Bexley Planning Commission

Planning Staff Report – February 22, 2016

Parkview and Main apartments – Conceptual Review

Application #: 16-000

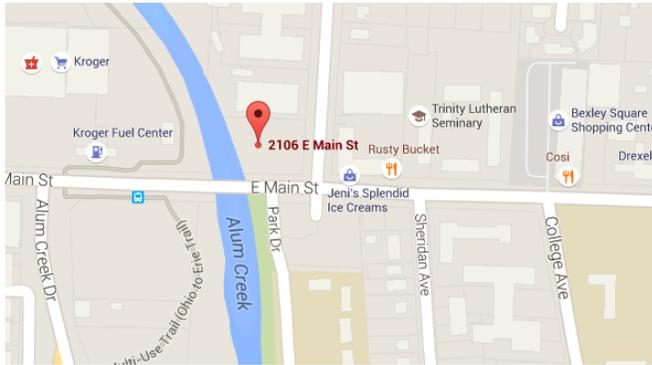
The applicant seeks environmental review for a mixed-use infill project along the Main Street Corridor. As in all projects of this type, there are some complexities involved with developing infill along a mixed-use urban corridor. As such, staff is considering this month's Planning Commission review to be more along the lines of a conceptual review in order to begin the process of understanding a number of issues.

Overall, staff is very supportive of this type of development approach, providing a mixed-use multi-story structure along Main Street. The proposed development follows the fundamental Main Street Guidelines principles, including:

- Building fronting on Main Street with little or no setback from the public right-of-way
- A mix of uses
- Front door access from Main Street
- Avoiding surface parking / visible parking along Main Street frontage
